SCHOOL OF  
ENGINEERING   
& APPLIED SCIENCE

University of Virginia  
Reactor Facility  
Charlottesville, VA 22903-2442  
804-924-7136 FAX 804-982-2634

Subject: Proposed amendment to UVAR [Facility License R-66,  
Docket 50-62] Technical Specification Figure 6.1

Figure 6.1 Organizational Structure of U.Va. Reactor Facility

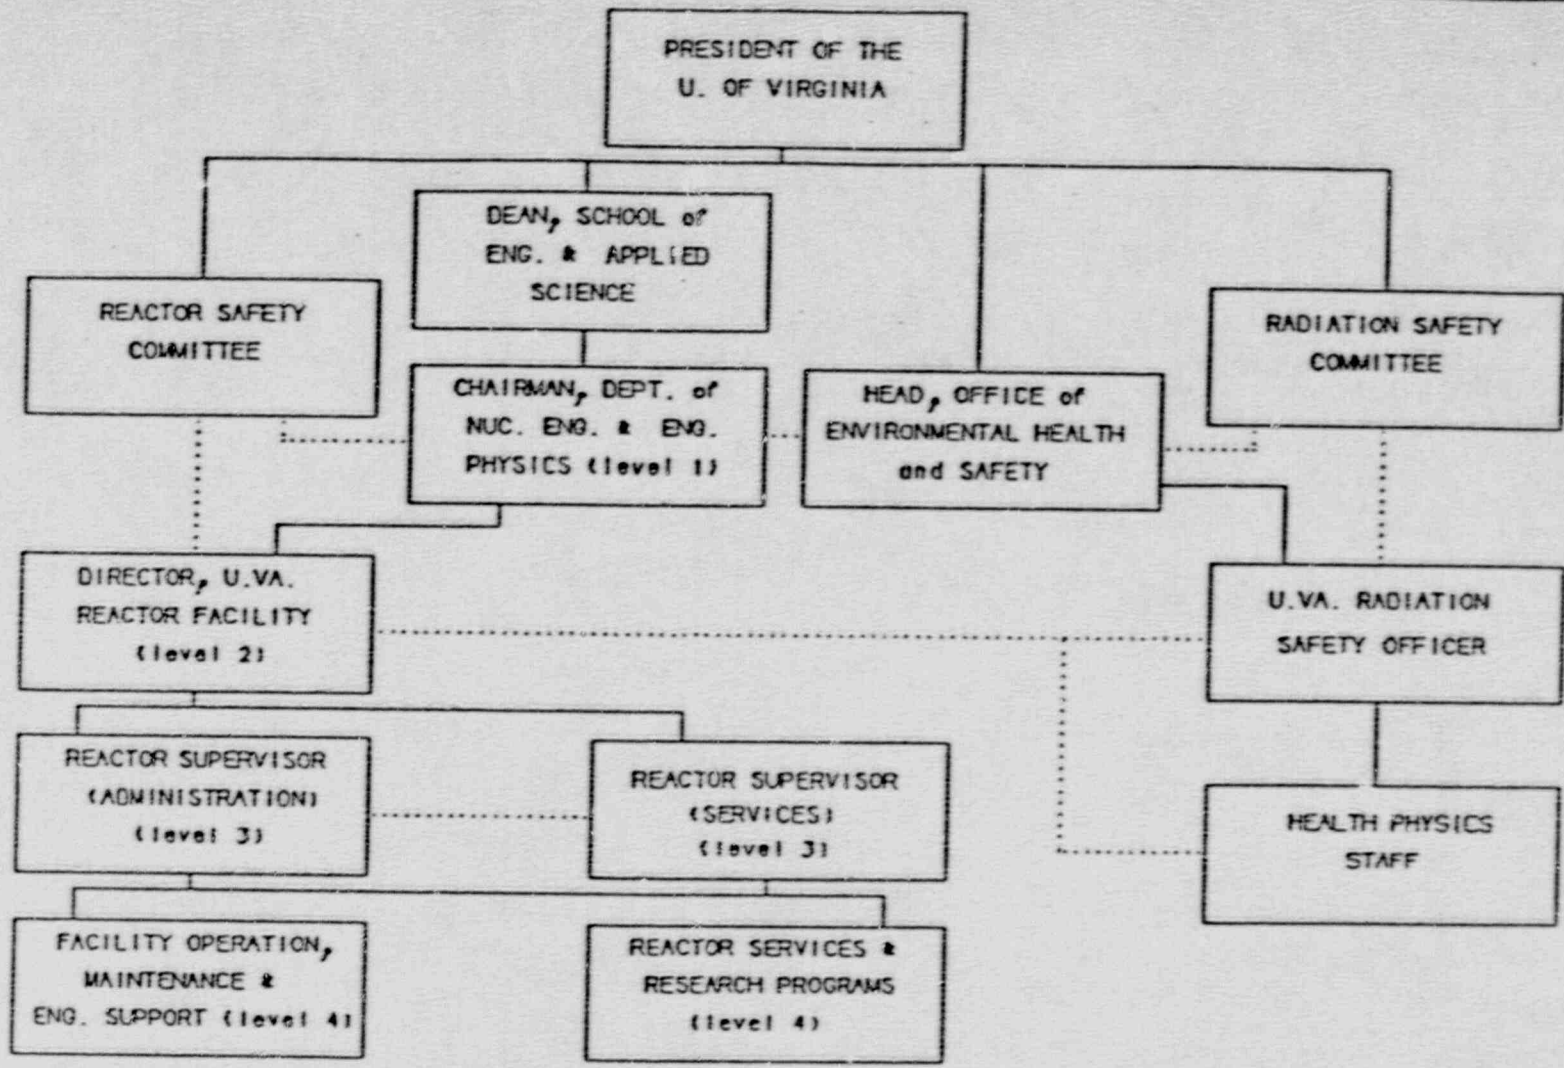
The University of Virginia Reactor Facility management respectfully requests NRC approval of an amendment to UVAR TS Figure 6.1. The enclosed figure was approved by our Reactor Safety Committee on July 2, 1990.

The figure is an update of the current figure listed in the UVAR Technical Specifications. It reflects the desired U.Va. Reactor Facility organizational structure into the foreseeable future. Given that the important independence between health physics and reactor operations continues to be maintained, these minor changes in channels of responsibility and communications should be allowed by the NRC.
